Burlington Design Advisory Board

DESIGN ADVISORY BOARD Tuesday, September 13, 2022 3:00 PM

MEMORANDUM

To: The Design Advisory Board
From: Mary O'Neil, AICP, Principal Planner
RE: 45-47 Lakeside Avenue ZP-22-485
Date: September 13, 2022

1978 site plan associated with installation of the carport.

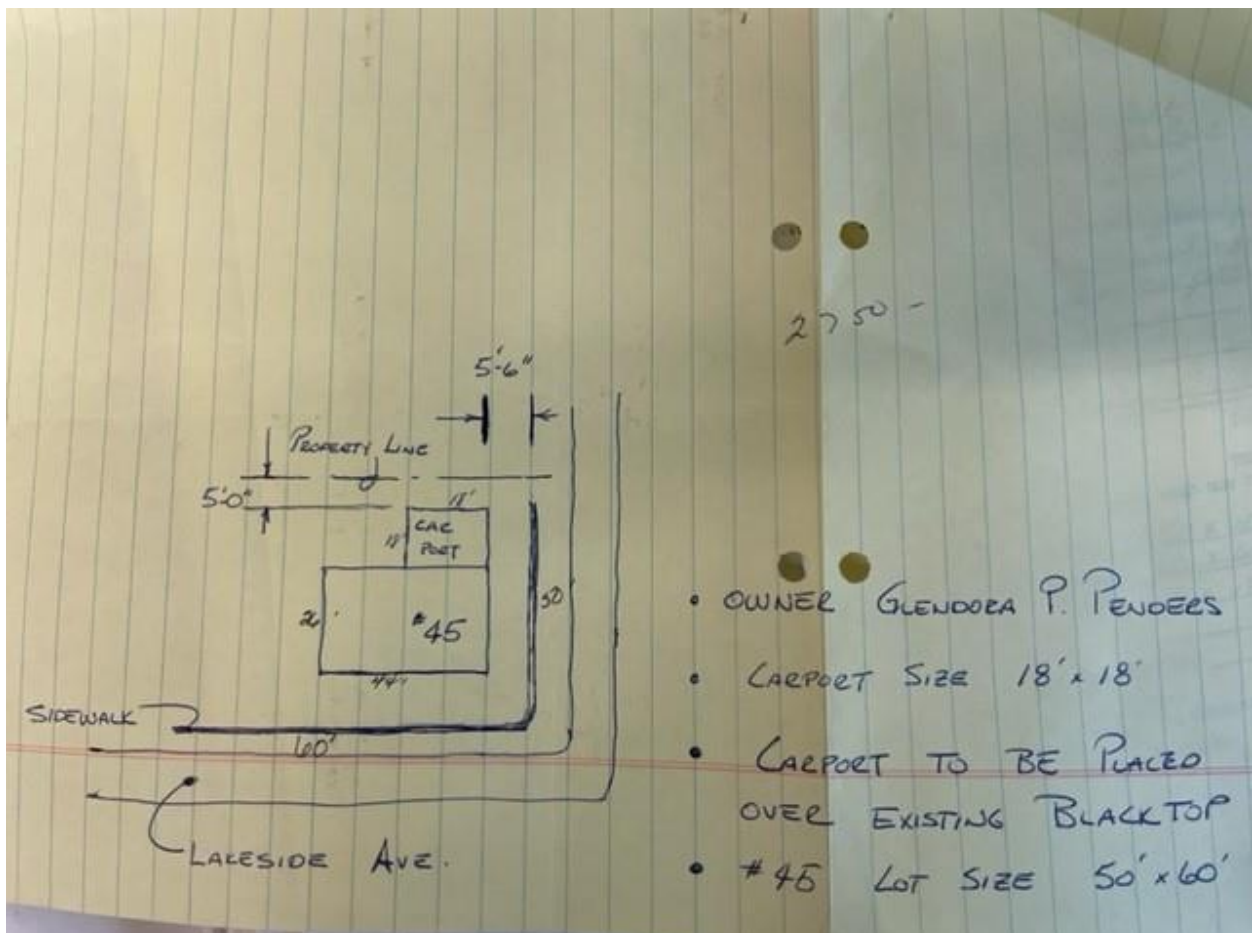
Dimensions of features are not provided on the submitted plan; nor is the plan an official survey of the property. From the coverage description it appears that each concrete strip will be approximately 38' long or enough for tandem spaces. Google Earth measurements provide a parking length 29' long to the easterly edge of the carport, while a vehicle is shown exceeding that footprint. The 1978 site plan limits the lot coverage of the carport to 18' x 18' with two parking spaces, so any parking east of that dimension exceeds the 1978 approval.

Although parking is illustrated in the same location as existing, lot coverage is calculated for lot coverage purposes not just on the tirepaths, but where the vehicle is parked. This reflects that the area is not functionally pervious if parking is occurring there. The lot coverage, therefore, remains impervious where vehicles are parked. Section 8.1.11-1 requires 8 x 16' for a single parking space (8 x 36 for tandem); for four parking spaces in tandem side-by-side would be 576 sf – the tire tracks up to that parking area must be counted as well. For this limited area, most of the existing lot coverage will remain.

Note that there is no pavement east of the (18' x 18') carport and only spaces identified in approval.

- Lot coverage is still calculated where vehicles are parked, so a revision must be made to the plans (dimensional measurements needed) to correctly calculate what, if any, diminishment of lot coverage may occur with the removal of the asphalt. The carport is not historic.
- The removal of dual front porches and replacement with a connected porch introduces a conjectural feature inconsistent with the time period of the construction of this Colonial Revival duplex; and diminishes the historic integrity of this structure and the overall historic district.

PROPOSED BUILDING ELEVATIONS

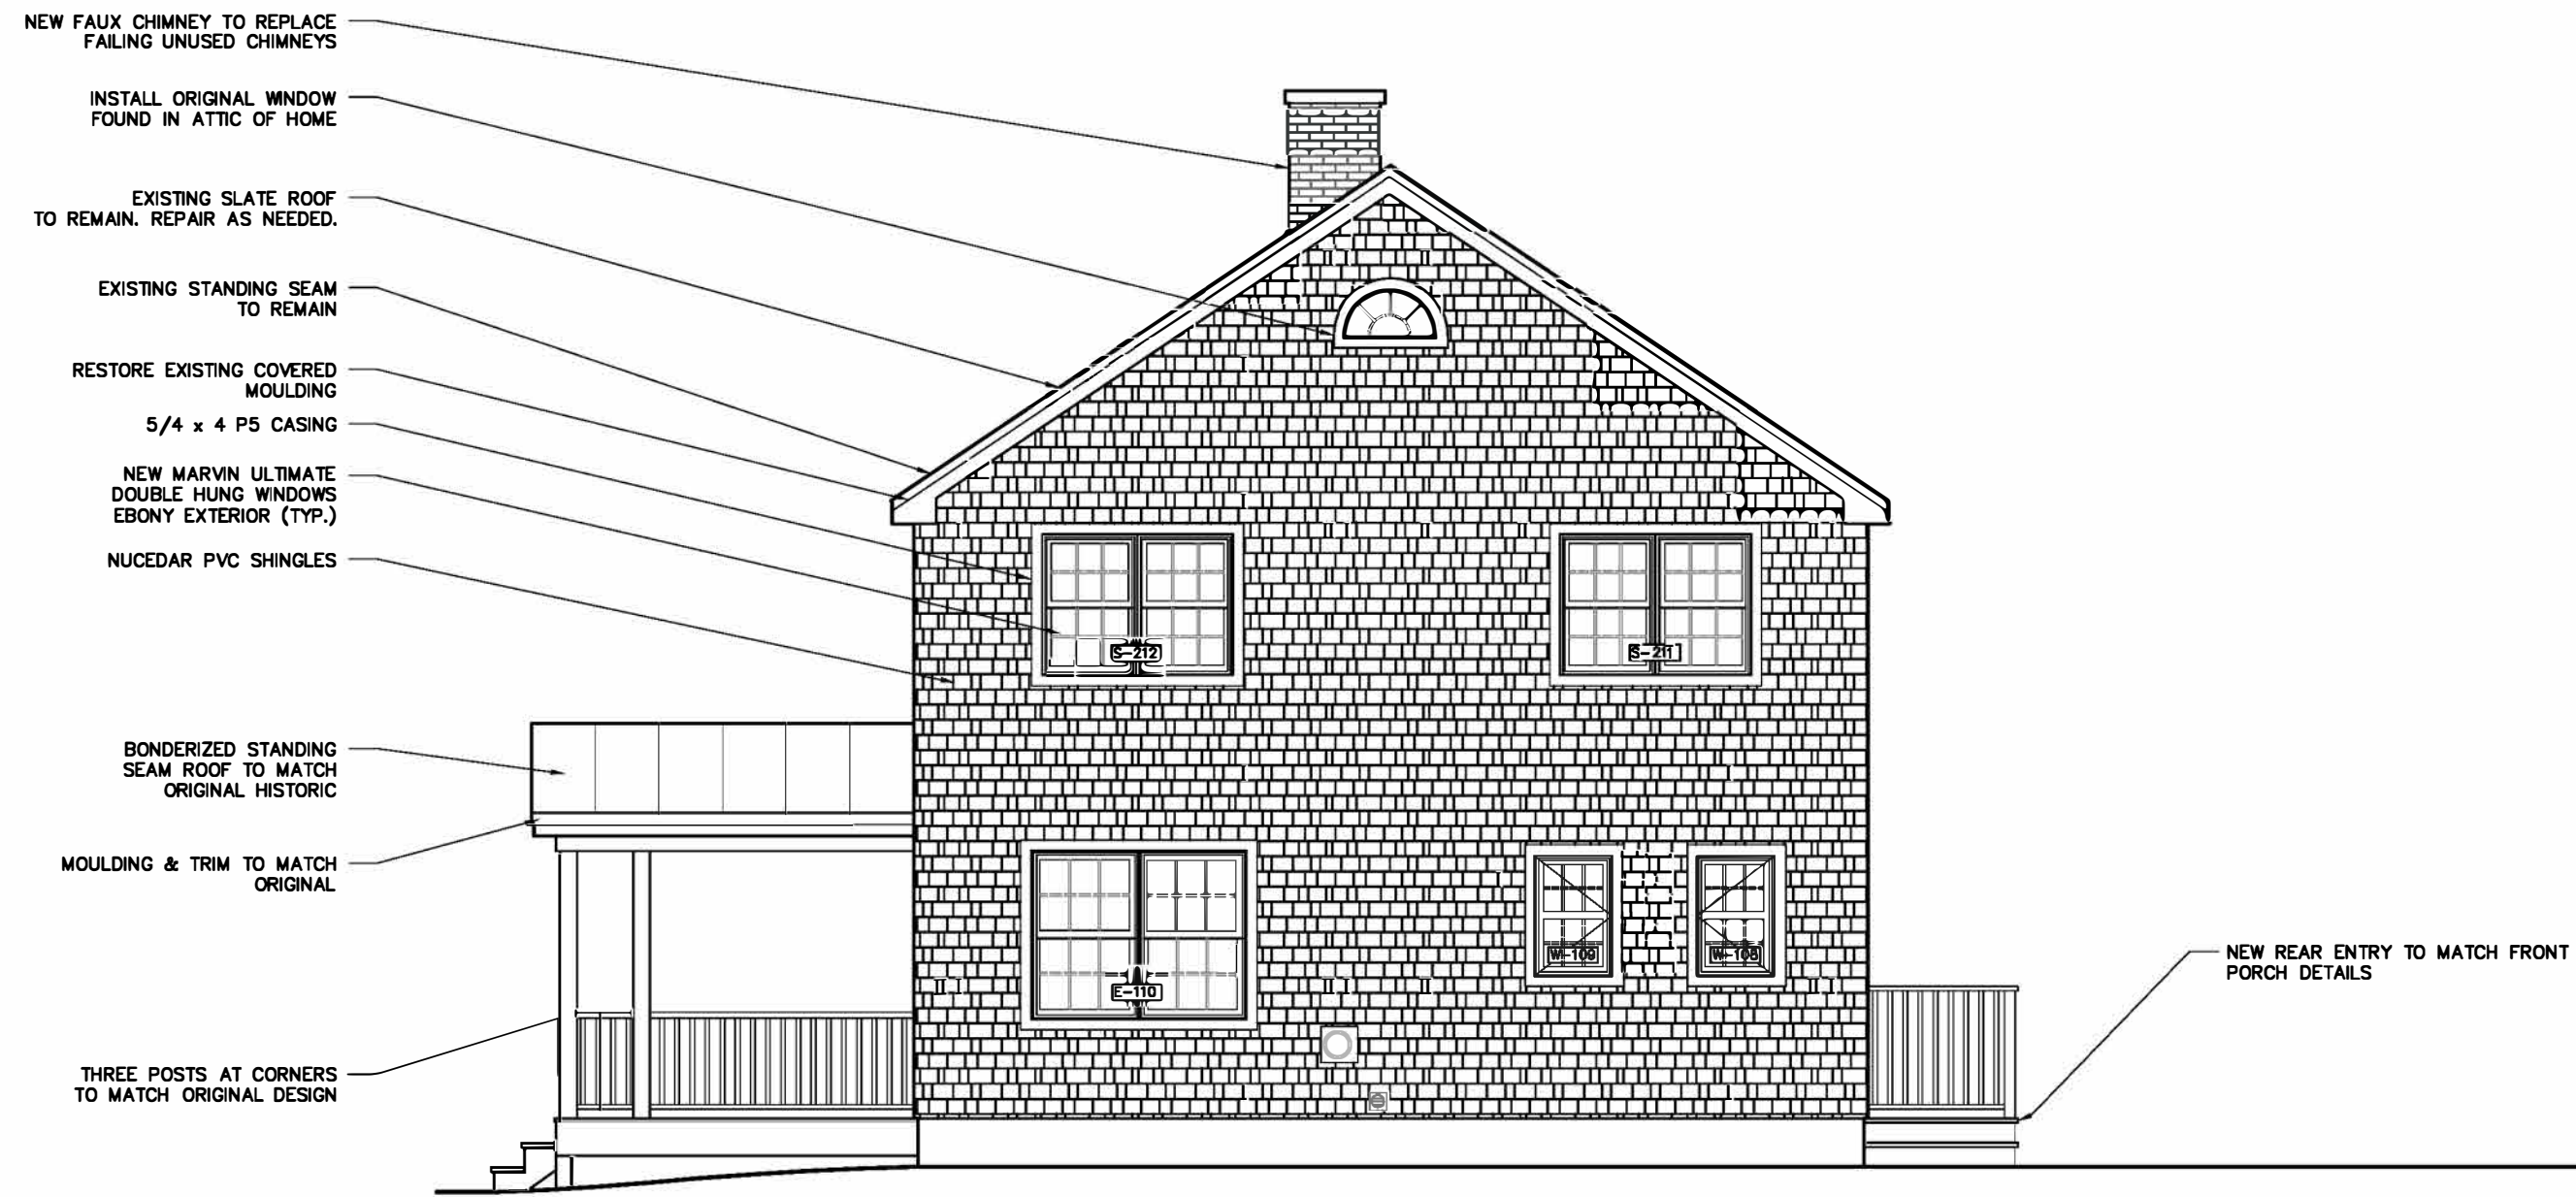
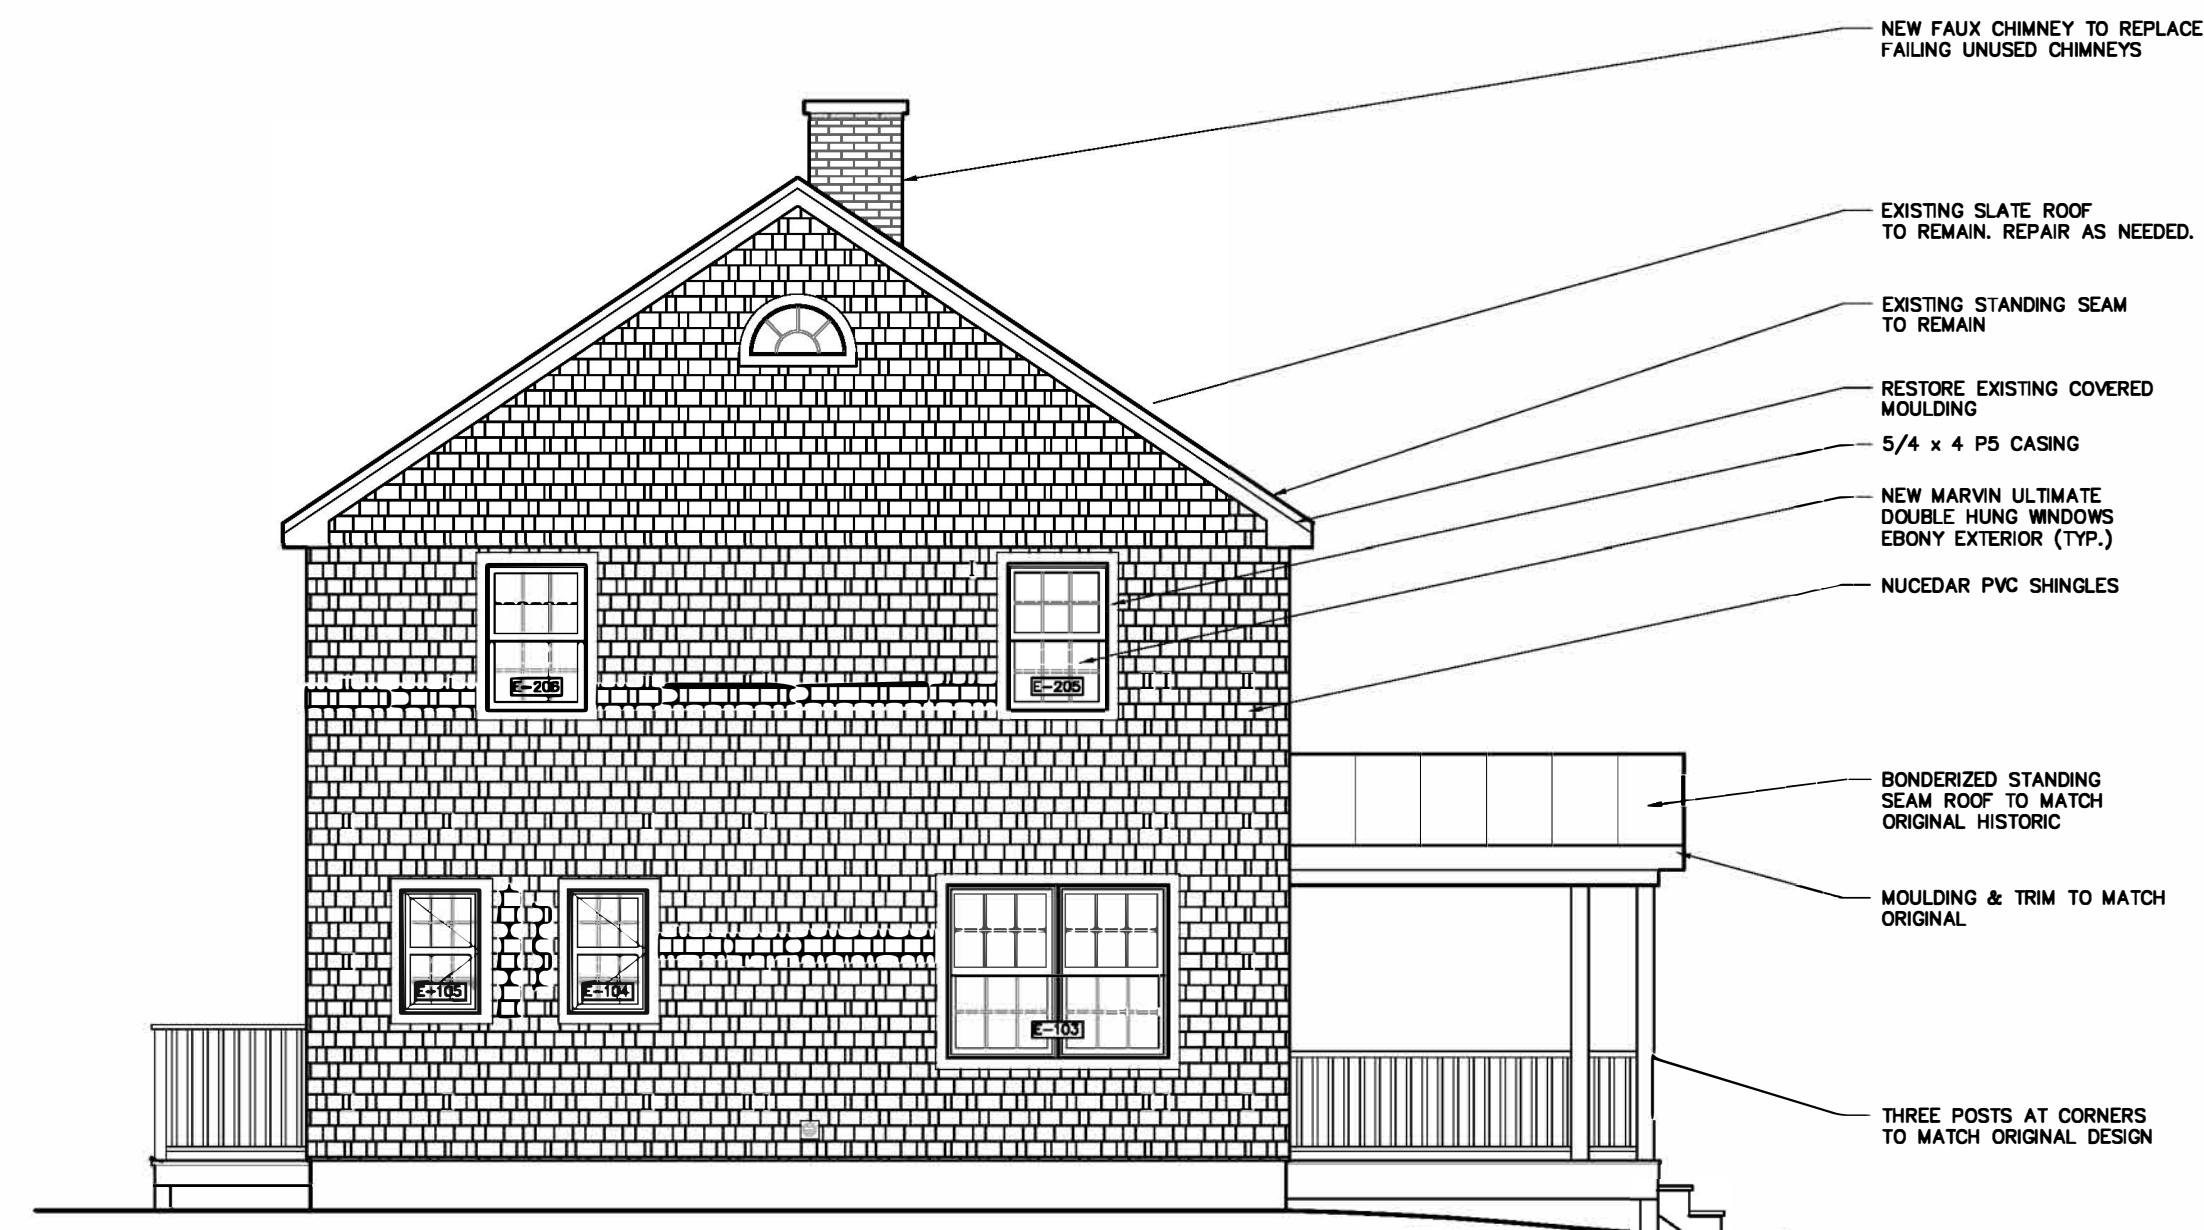
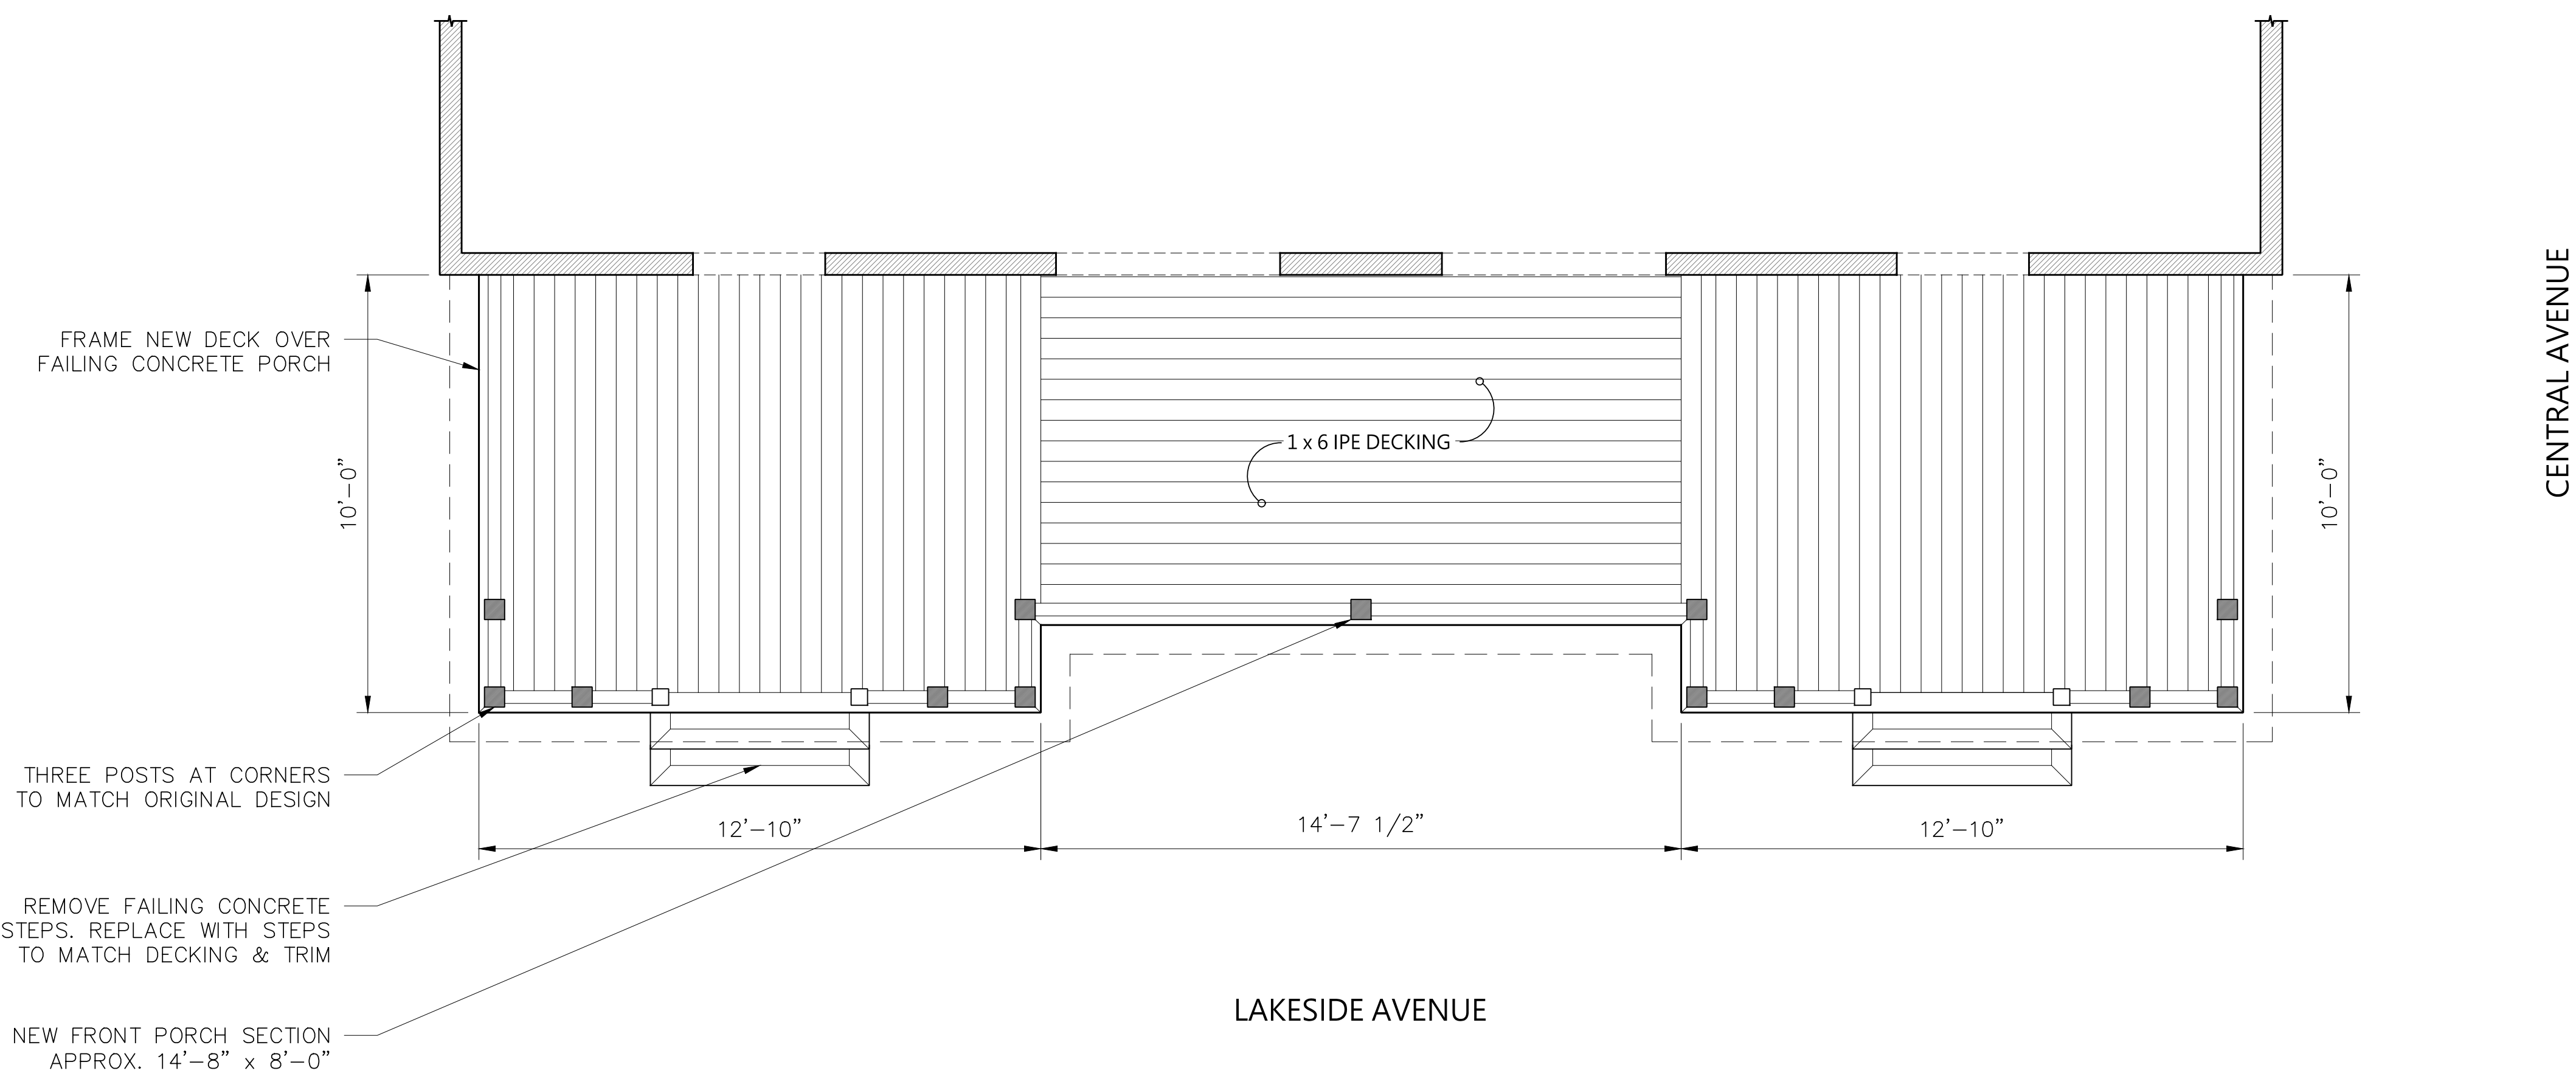
While the height and scale of the structure will remain as existing, the massing is somewhat altered by the proposed porch enlargements/extension. The proposed plan is not consistent with the original massing of the porch, and contrary to the characteristics as recorded in the Lakeside Historic District National Register nomination.

A standing seam roof is proposed for the connected porches. Sanborn Fire Insurance Map details indicates the original porch roof was a “composition roof” (typically an asphalt product.¹) The

pediment-styled roofs are proposed for the new construction, spanned by a shed roof. This replacement porch diverges from the colonial styled separate porch entrances associated with this last group of dwellings constructed for the Cotton Mill employees. Similarly, the three-corner-posts are clearly from the Colonial Revival style and must be retained or reproduced.

The connected porches was not an original feature of these duplexes; in fact almost all the duplexes within the community had individual entry porches in 1942. To alter the porches would dilute the Colonial Revival character of the structure and introduce an alteration within of the Lakeside district.

To replace historic dual porches with a single connected porch will change the spatial arrangements and features that characterize the property; impacting the integrity of the property and the historic district overall.

The introduction of a large, connected front porch is inconsistent with the original character of the structure and diminishes the historic integrity of the building with removal of the characteristic dual porches. While removal of this connected porch may be feasible in the
